Date Issued :	May 31, 2022	PCN Number :	512104
Reason for Change :	Obsolete		
Description of Change :	Please be advised that these Part numbers from the QSFP+/ZQSFP+ Ganged cages product families are being made Obsolete with replacement. The inner spring fingers of the offered replacement parts will be made of Stainless Steel & will also undergo laser welding during the assembly process		
Reason for Short Notice :	Force Majeure		
Planned Implementation Date :	October 10, 2022		
Recommended replacement parts :	Please see the attached replacement parts list .xls file.		
Last Time Buy Date for Obsolete Parts :	June 15, 2022		
Last Time Ship Date for Obsolete Parts :	September 22, 2022

Overview

ZQSFP+/QSFP+ Cage with EMI Gasket & inner spring Fingers

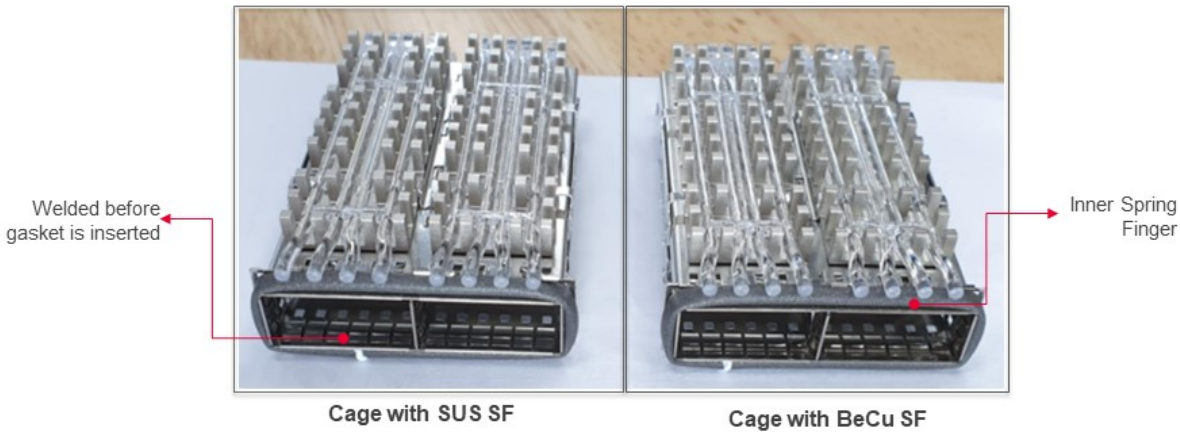
- Please be advised that the following Part numbers from the QSFP+/ZQSFP+ Ganged cages product families are being made Obsolete with replacement. The inner spring fingers of the offered replacement parts will be made of Stainless Steel & will also undergo laser welding during the assembly process.

- **Product Impact**
Weld joints will be the only effect to the form, no impact on fit or function based on test summary 1000154547 (available upon request).

- **Reason for Change**
Critical shortage of Beryllium Copper which is the raw material used in spring fingers of the affected parts.
